Project: **ROCKWALL HIGH SCHOOL RENOVATIONS**
FOR
ROCKWALL HIGH SCHOOL
ROCKWALL I.S.D.
901 YELLOW JACKET LN, ROCKWALL, TX 75087

DETAILED ENTRY GRADING PLAN

100% CD	VOLUME
Job No. 1738-02-01	Sheet No. CG
Drawn By: RAH	1.0
Date: 12-03-2016

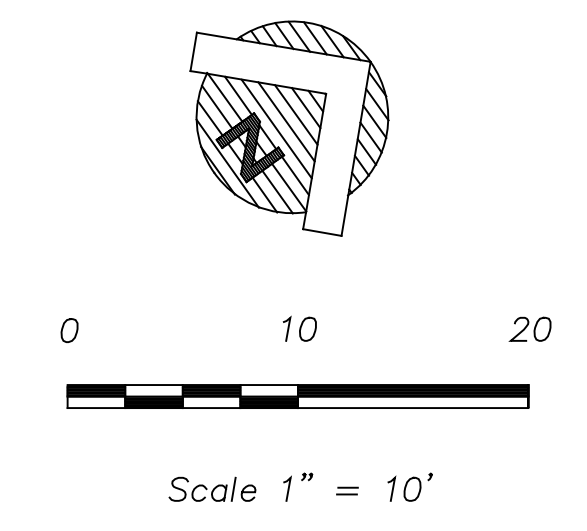
ADDENDUM #1
PC - REMOVE STORM FLUME AND PARKING
PC - REMOVED STORM SEWER
